**Addendum No. 001**

**Subject: 2020 Classroom Modernizations**  
**SDP Contract Numbers: B-028 C of 19/20 & B-030 C of 19/20**

**Location: Overbrook Educational Center**  
**6722 Lansdowne Ave, Philadelphia PA 19151**

**This Addendum, dated March 6, 2020, shall modify and become part of the Contract Documents for the work of this project. Any items not mentioned herein, or affected by, shall be performed strictly in accordance with the original documents.**

1 PLUMBING FIRST FLOOR NEW WORK PLAN  
MP1.1 1/8" = 1'-0" 0 4 8 16'

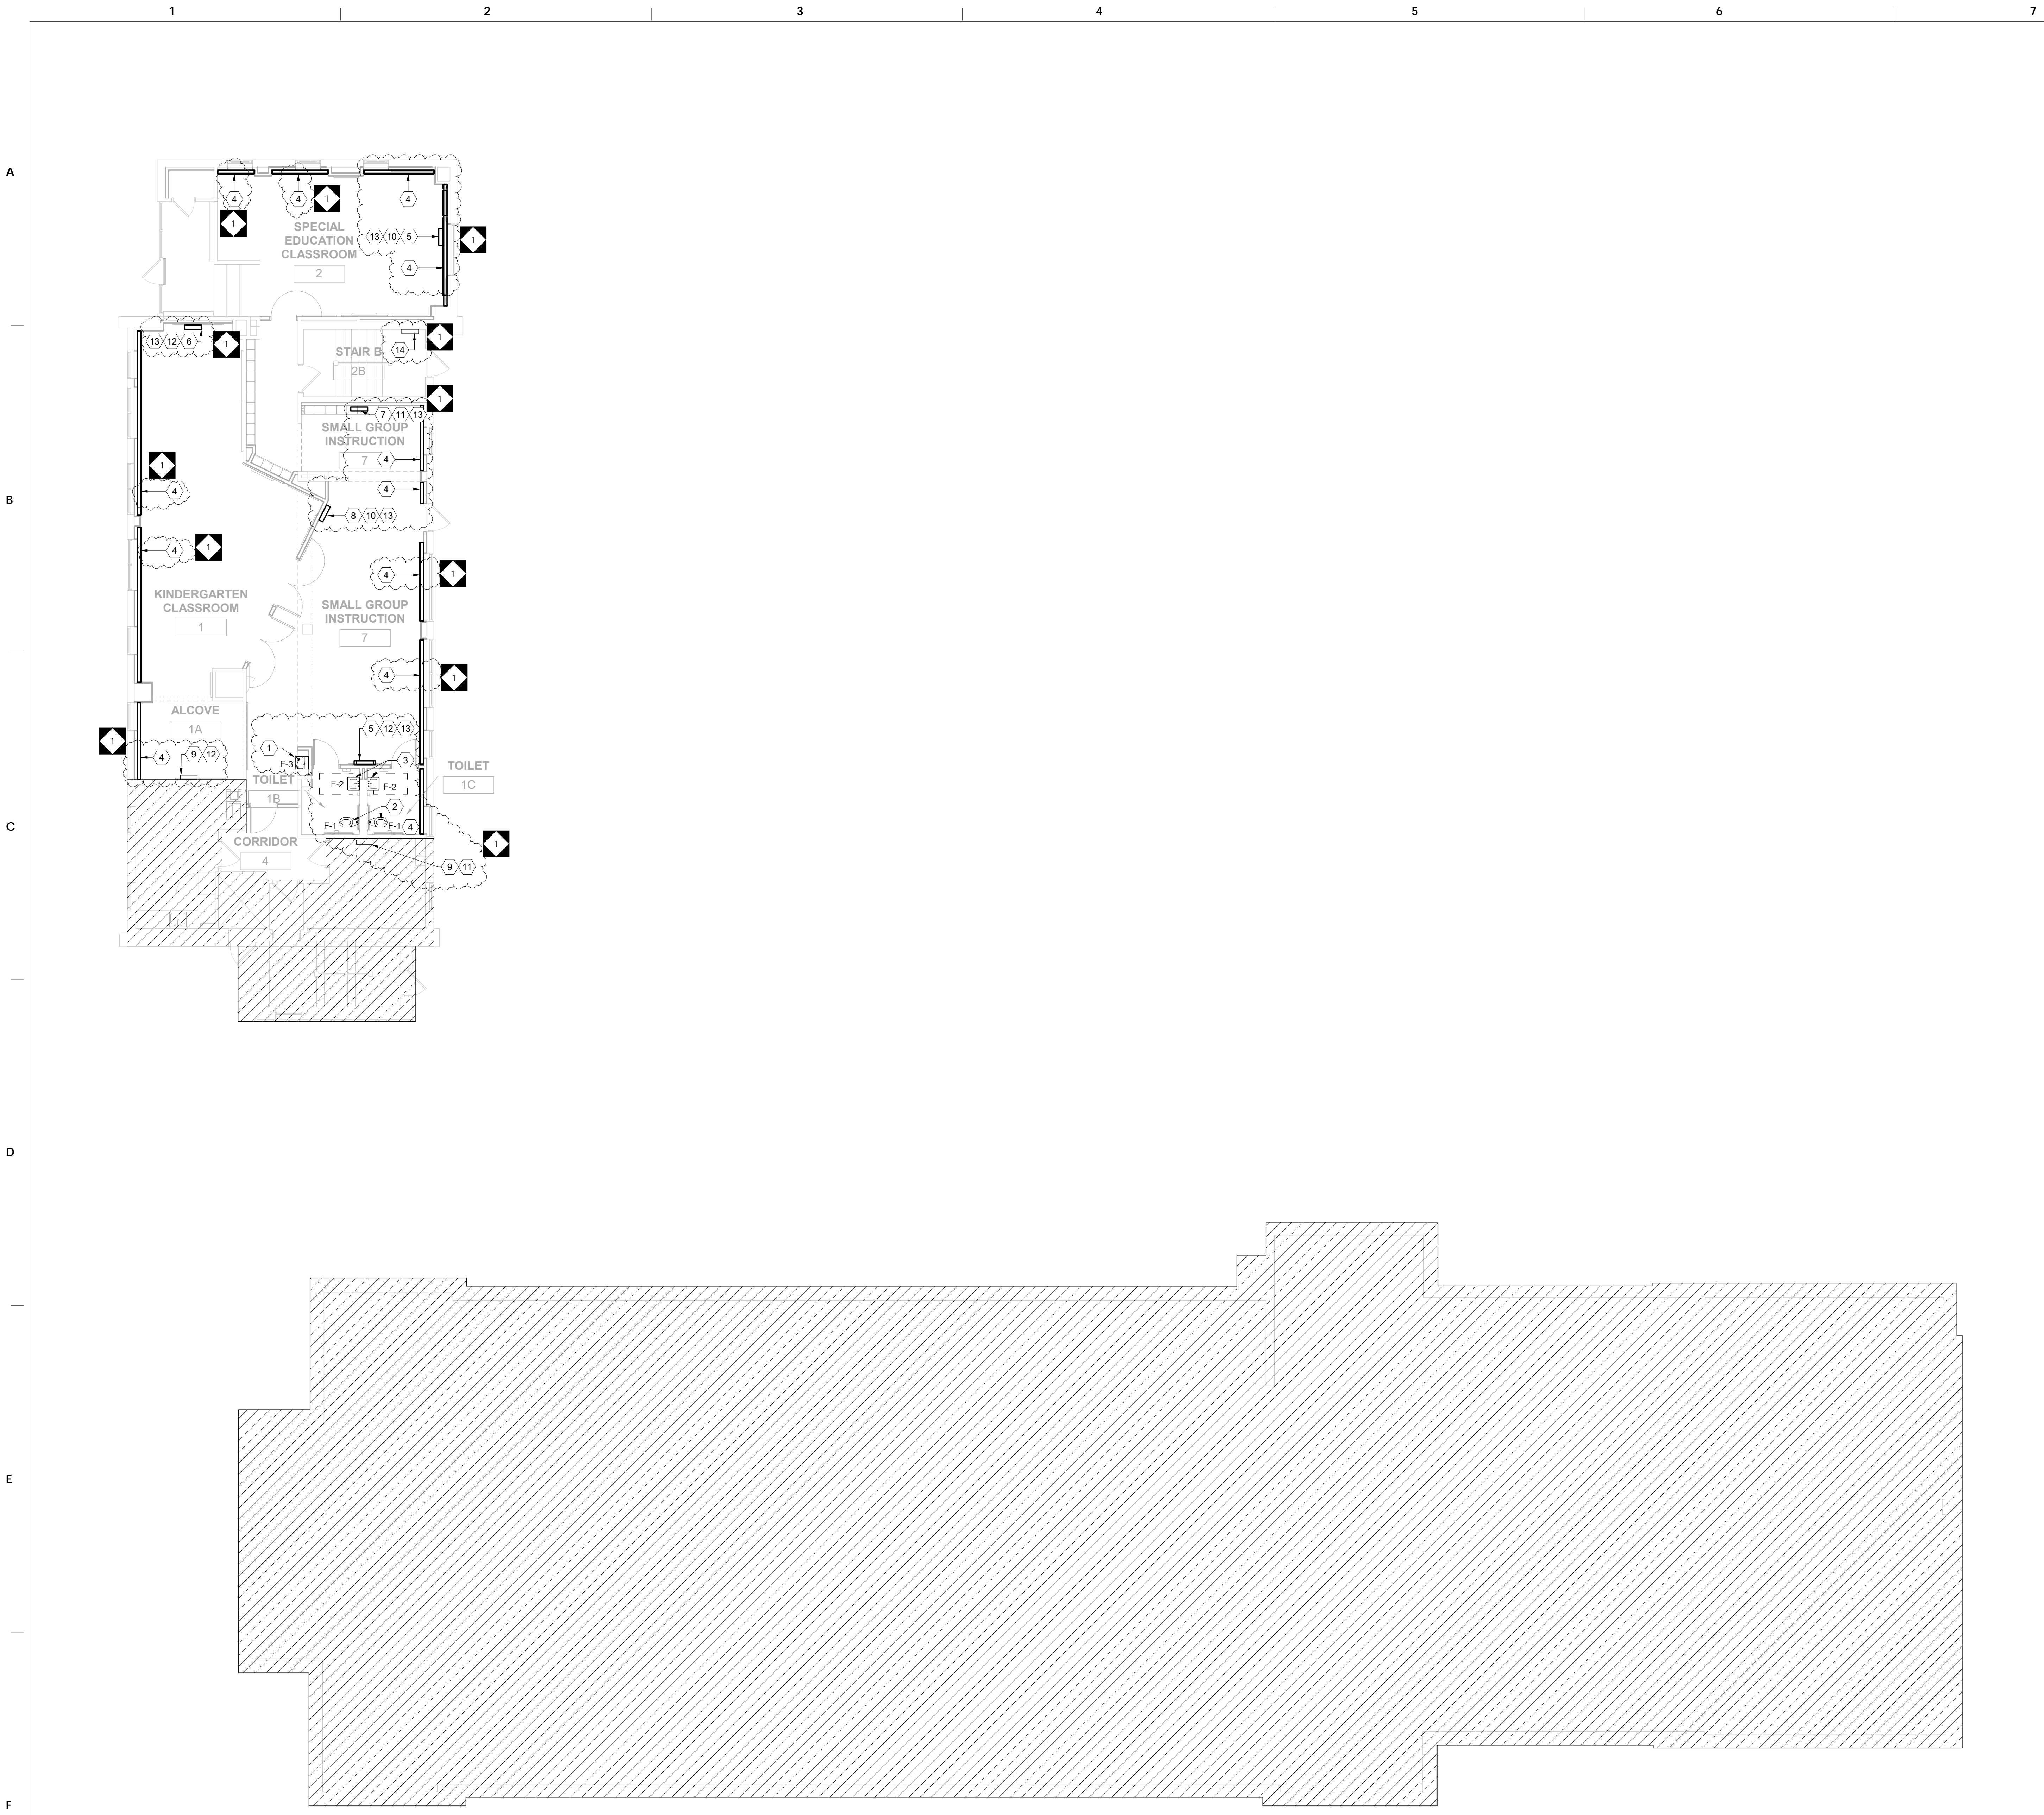
1. REVISE sheet number.
2. ADD Sheet Key Notes as indicated on the drawings.
3. REVISE scope as indicated on the drawings.

1 PLUMBING SECOND FLOOR NEW WORK PLAN  
MP1.2 1/8" = 1'-0" 0 4' 8' 16'

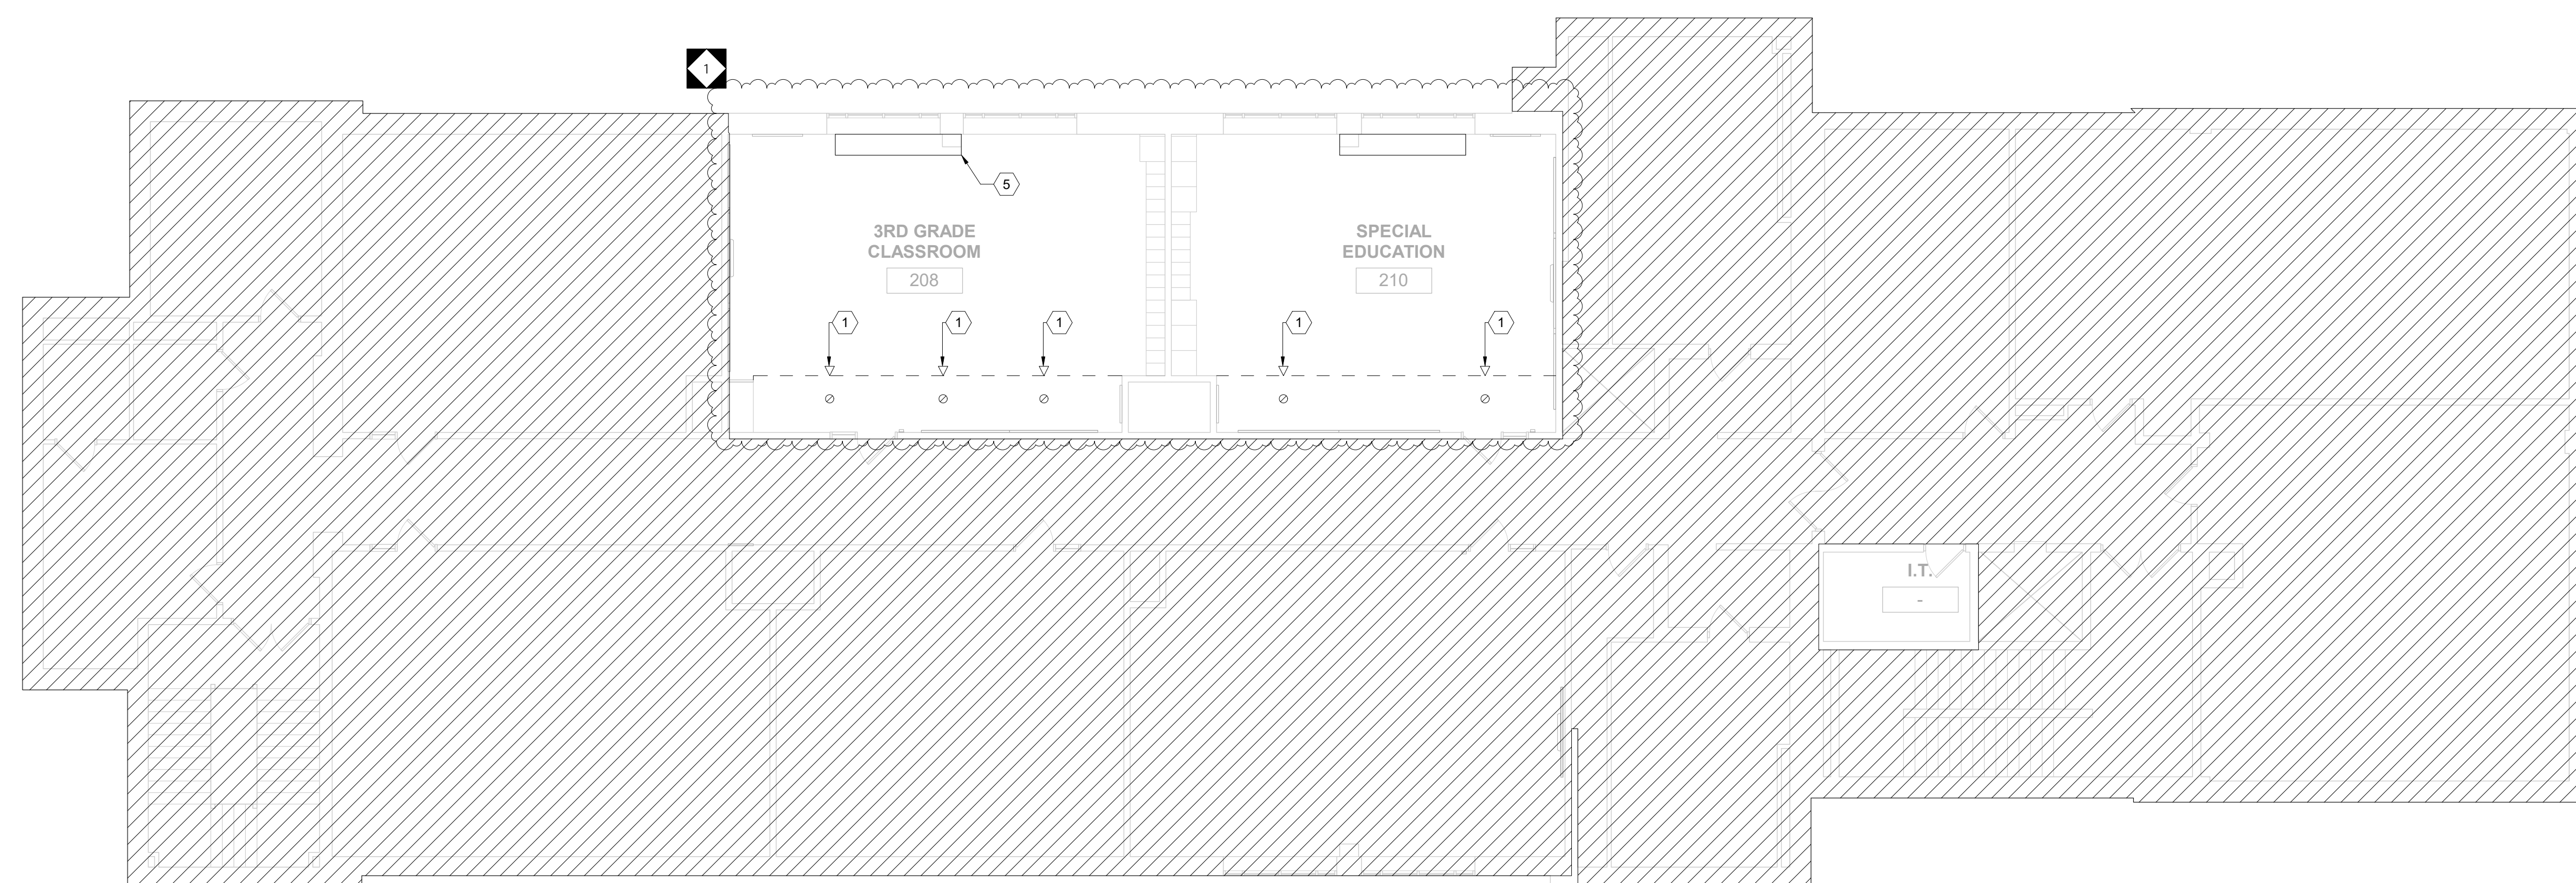
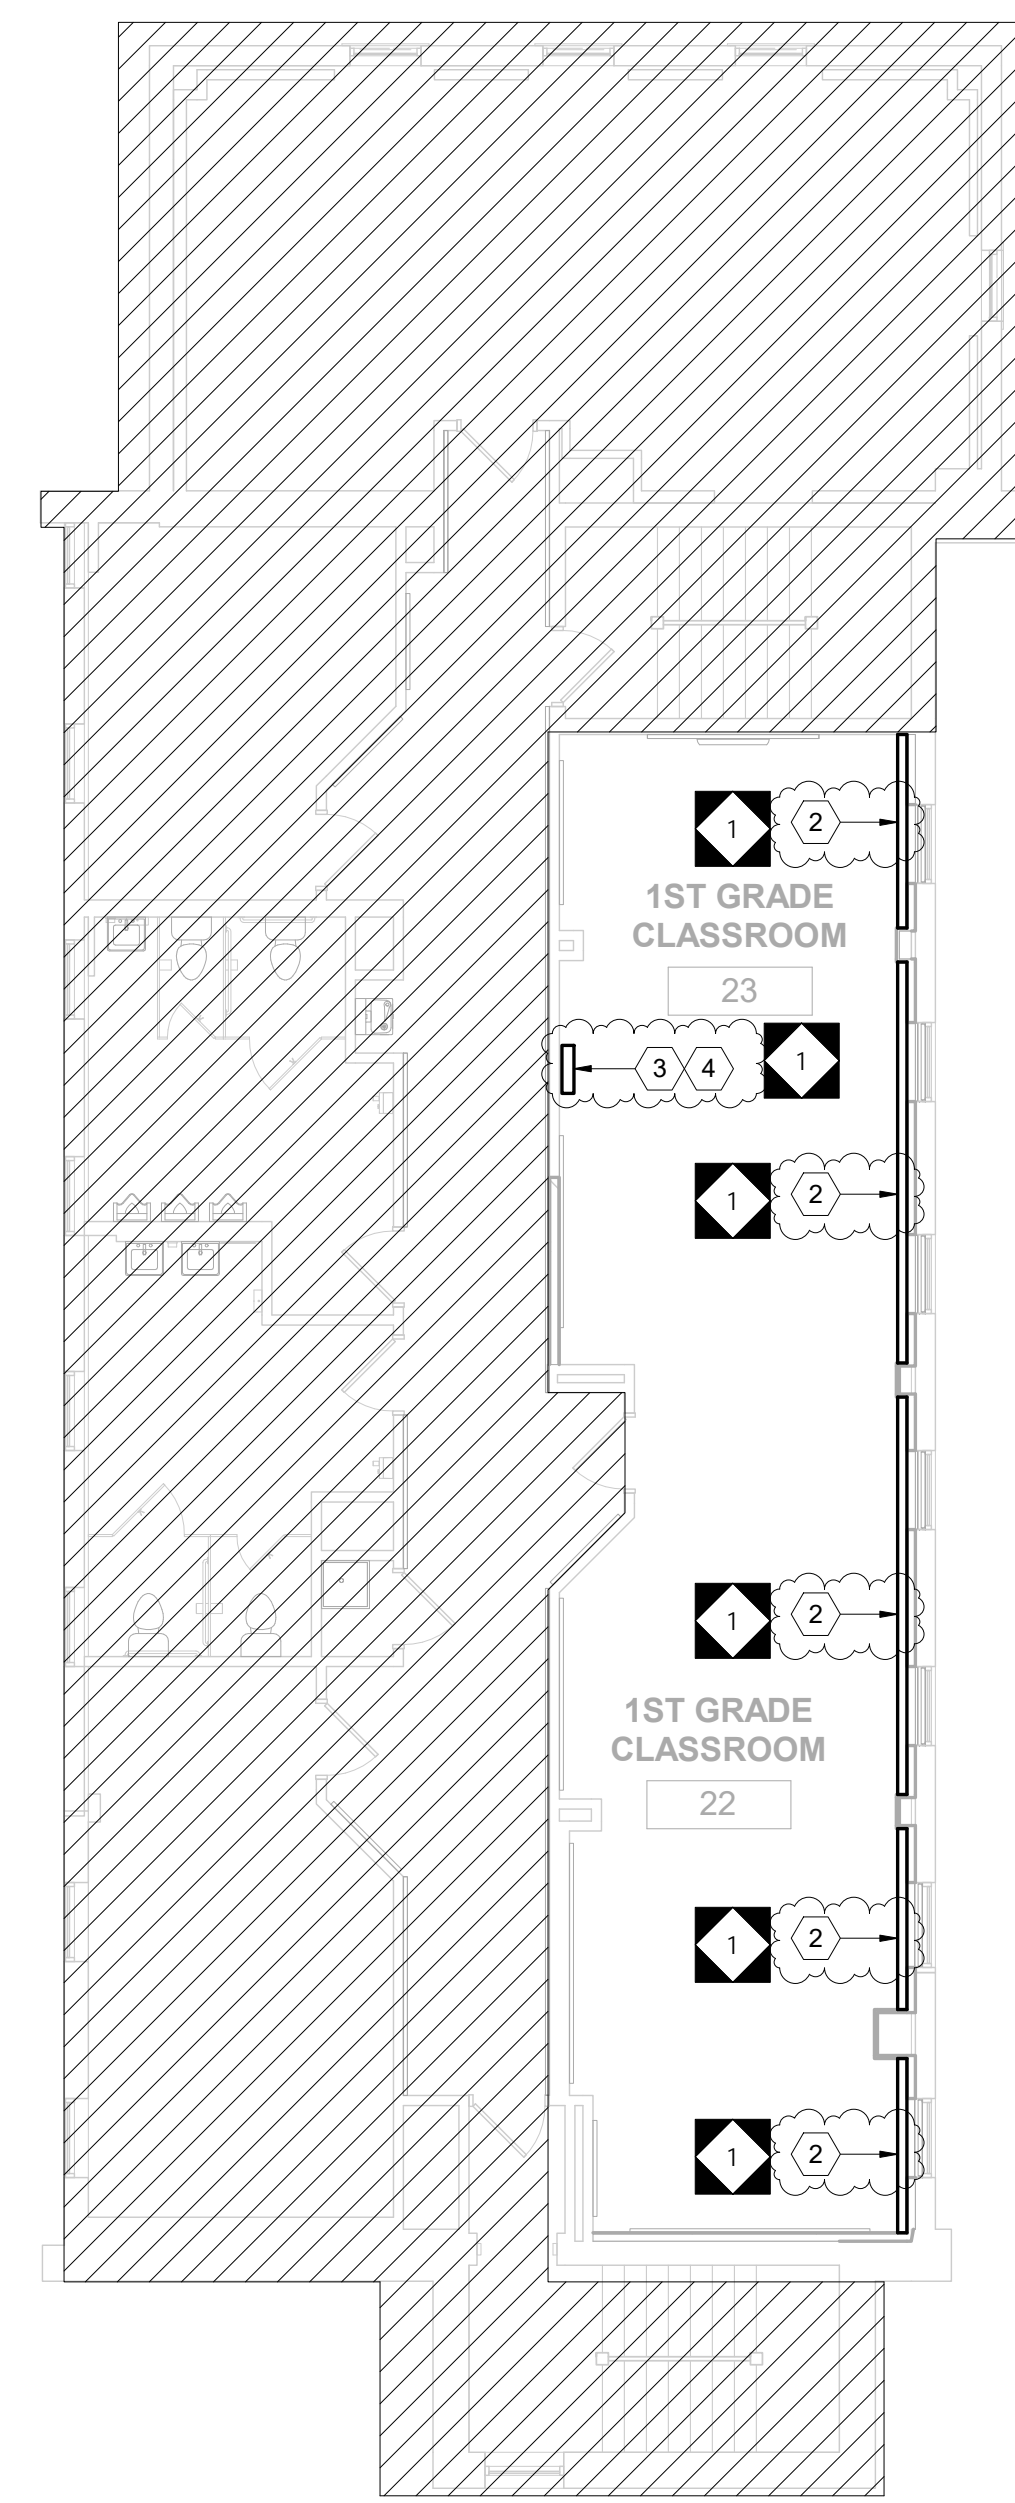
1. REVISE sheet number.
2. ADD Sheet Key Notes as indicated on the drawings.
3. REVISE scope as indicated on the drawings.
